citizenM Hotel
201 Westlake Ave N

SDCI Project # 3023379

Design Review Board
West Design Review Board

Date: September 6, 2017

Facade Panelization

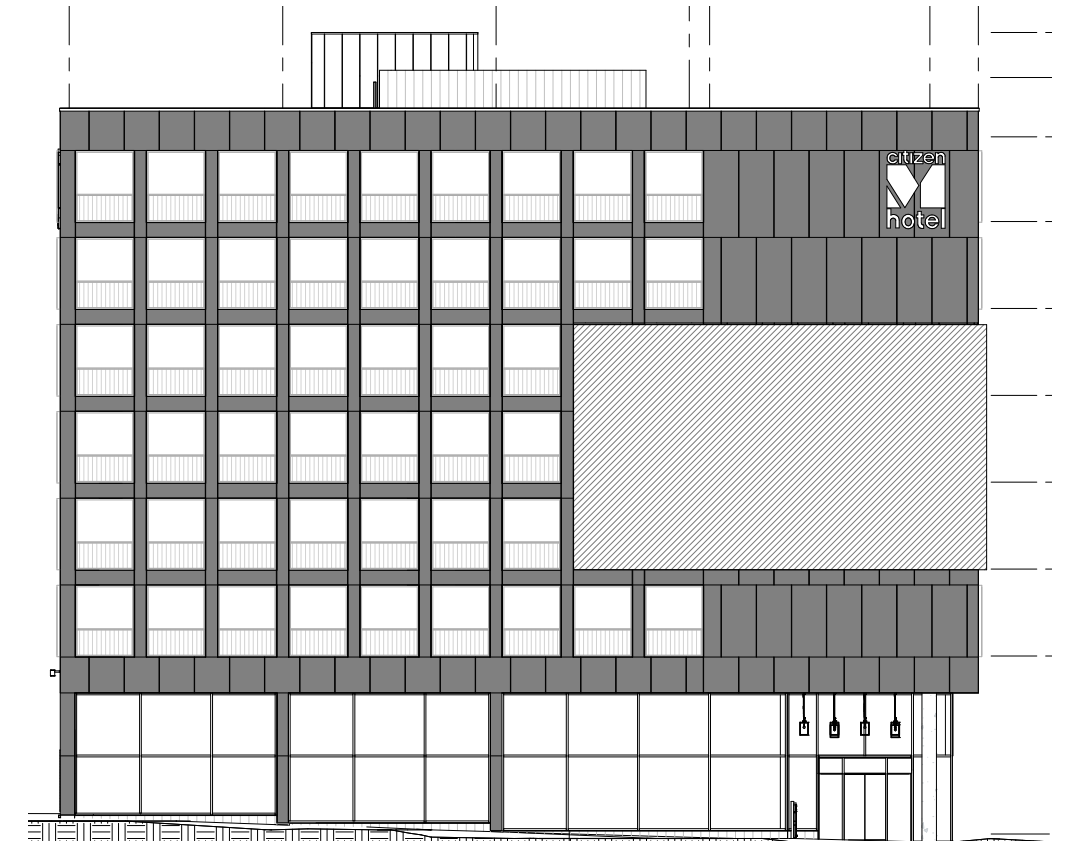
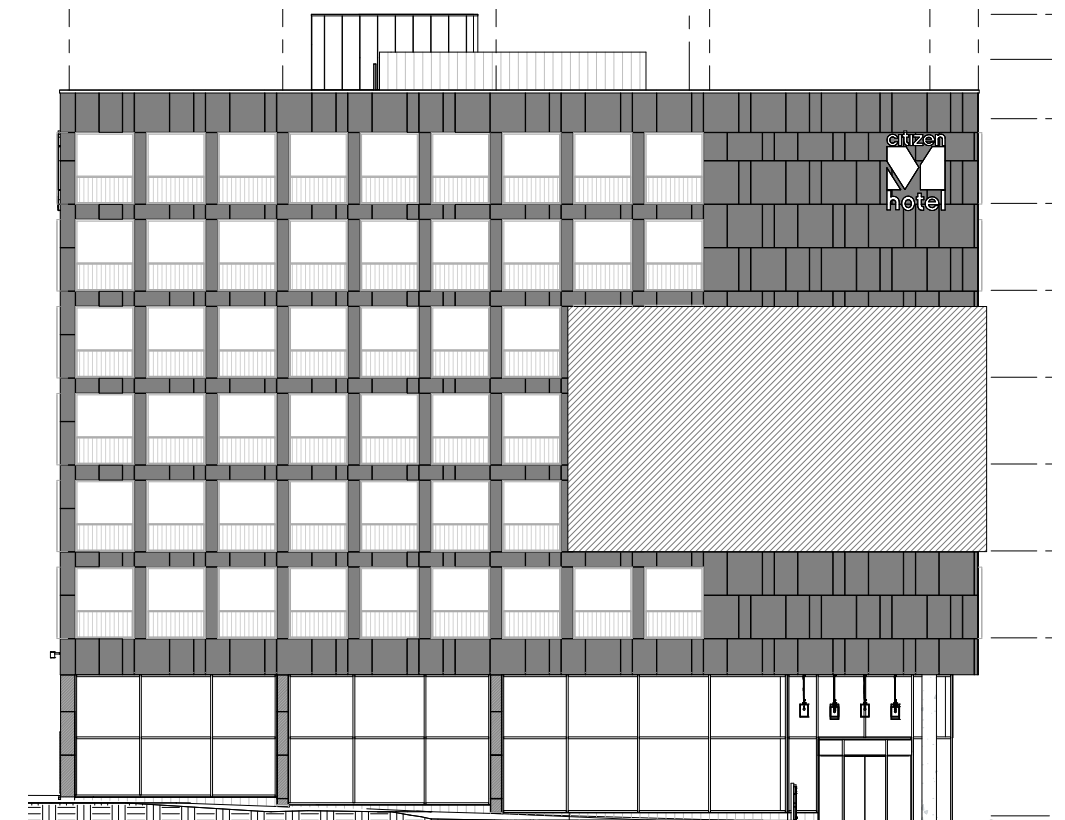
“...The Board strongly supported the quality of materials proposed and cohesive approach to detailing, including the staggered pattern and the added texture of the exposed fasteners of the Equitone panels. (DC2-B-1, DC2-D-2, DC4-A-1)... For the North blank wall, the Board supported the proposed monochromatic treatment using two contrasting tones of high quality Equitone panels. The Board approved the crisp appearance and the differentiation of the stair tower with contrasting tone and panel pattern (DC2-B-S, DC2-D-2, DC4-A-1)”

- The facade panelization pattern has been changed in order to eliminate construction waste. The Equitone fiber cement facade panels are manufactured in 4'x10' sheets. The previous pattern, which would have required many small cuts to achieve a sequence divisible by 5, would have resulted in roughly 20% of the 4'x10' sheet going to waste in a landfill. The new pattern, which relies on a whole 4'x10' sheet as the basic facade module achieves much greater material efficiency with far fewer cuts and waste.

- The 4'x10' facade module relates well to the scale and proportions of the architecture. The floor-to-floor height, for instance, is 10'. 4' is almost exactly half the width of the 8'-2 1/2" wide guestroom modules.

- The North (blank) facade will continue to make use of two different tones of Equitone panel (light gray and dark gray) to break up the mass and articulate the taller height of the stair tower in relation to the rest of the facade.

- The new panel module spacing will also establish a more regular rhythm of the exposed metal fasteners as there will be fewer changes in the spacing sequence.

John Street Facade

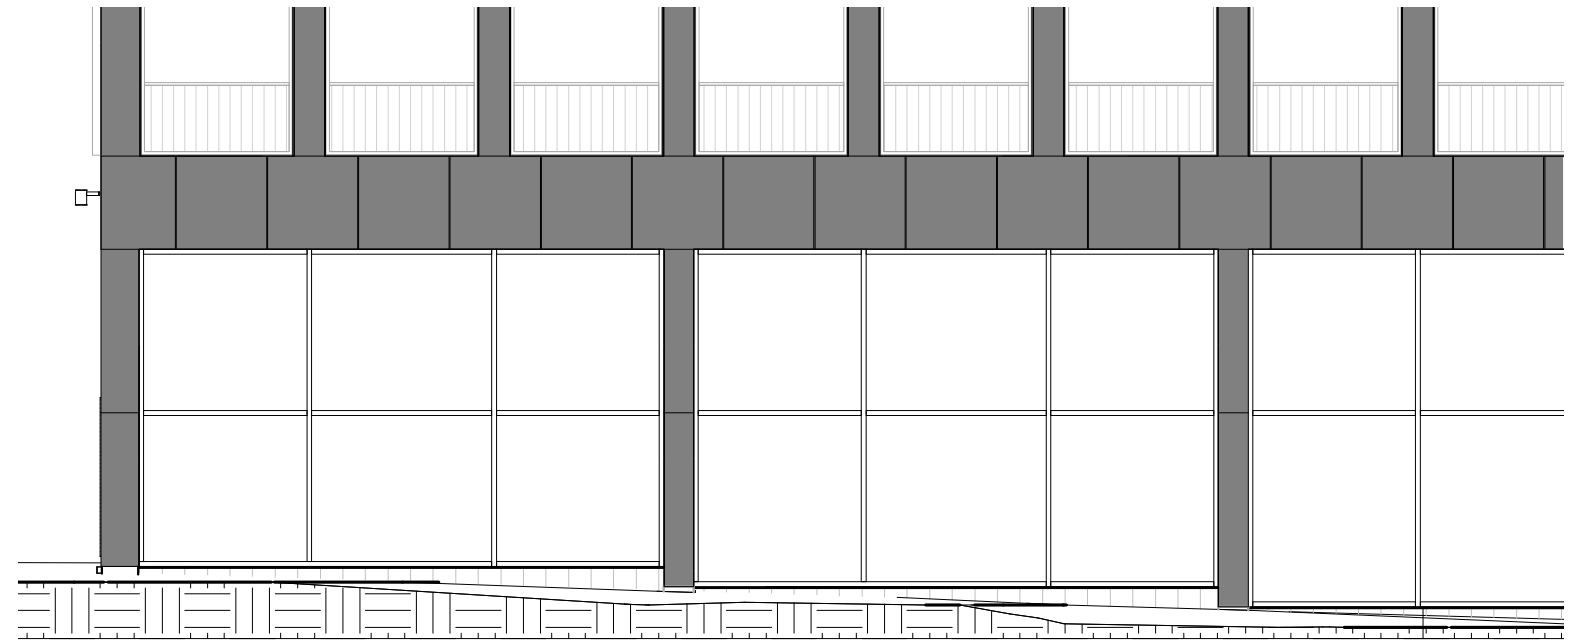
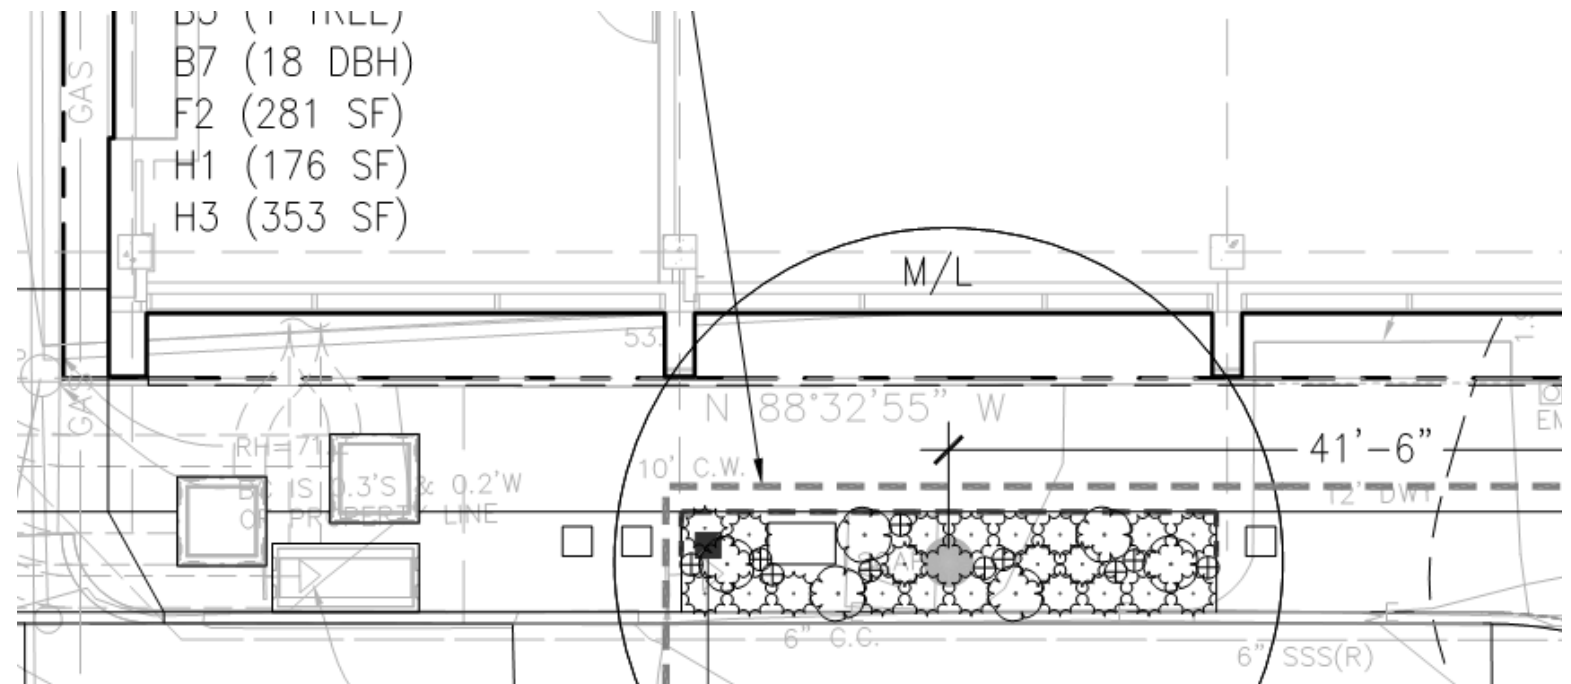
- The planters along the John Street facade have been eliminated. Nearby street planting, courtyard bioretention, and green roof will satisfy the required green factor.
